REQUEST FOR INFORMATION DATE: June 13, 2017 NO.: RFI-563

Project Name: 15051-Webster University Interdisciplinary Science Building Project No.: 15051

Subject: Dimensions of Handrail in Lecture Hall

1 SILL DETAIL AT LECTURE HALL

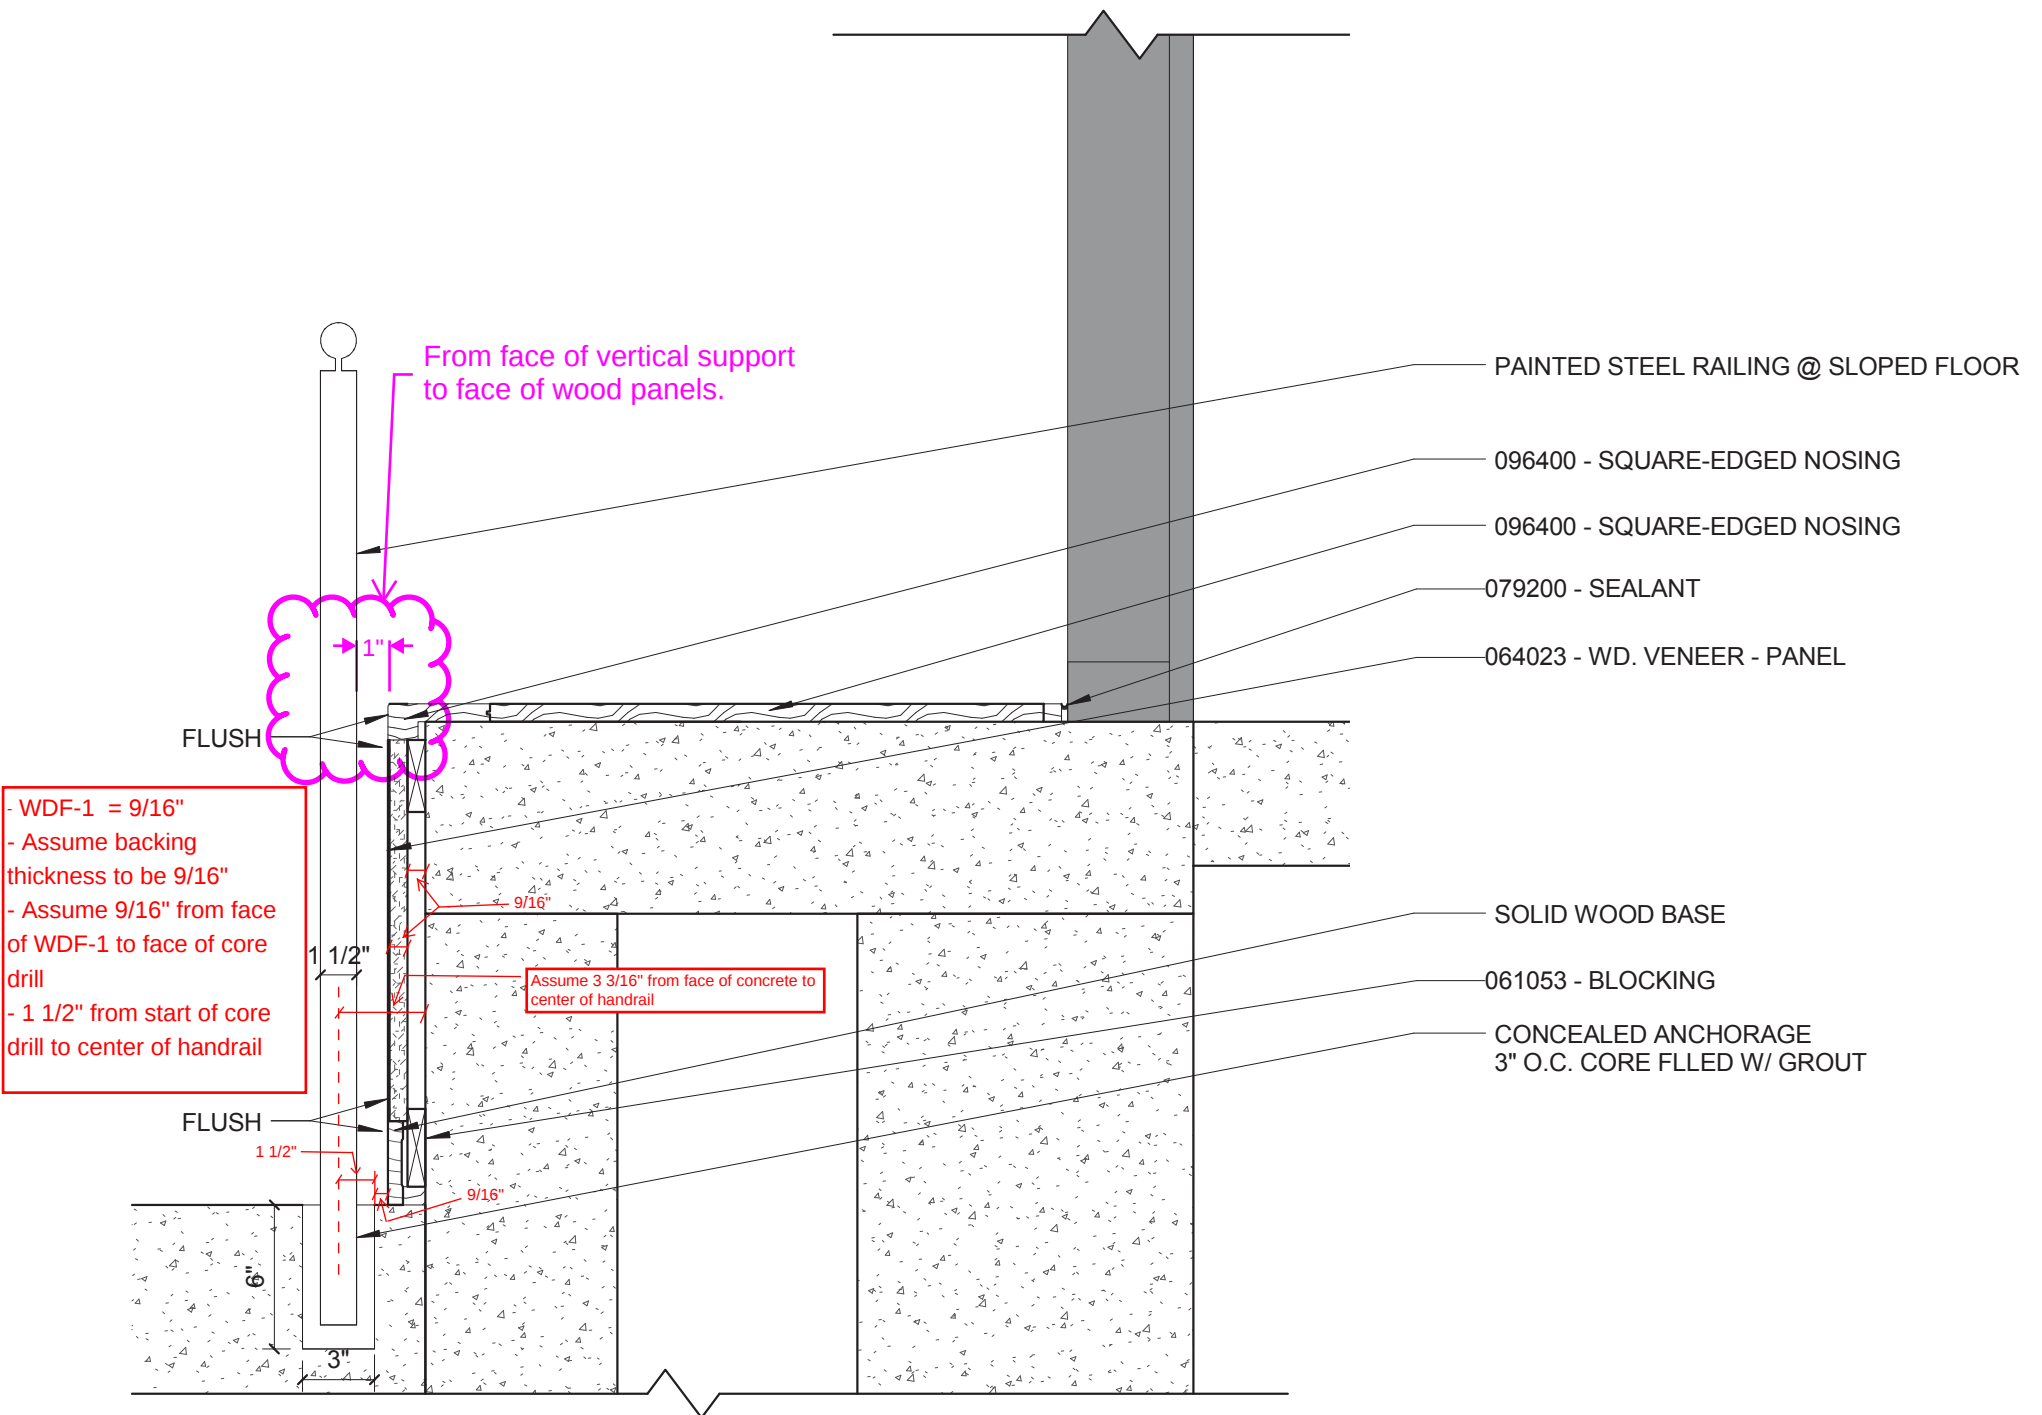
See attached markup. The dimensions of the handrail in the lecture hall are not called out on the plans. We have come up with a markup that includes what we think the dimensions are supposed to be (3 3/16" from the face of concrete to center of handrail). Please review and confirm the dimensions.

Locate per markups (magenta color).
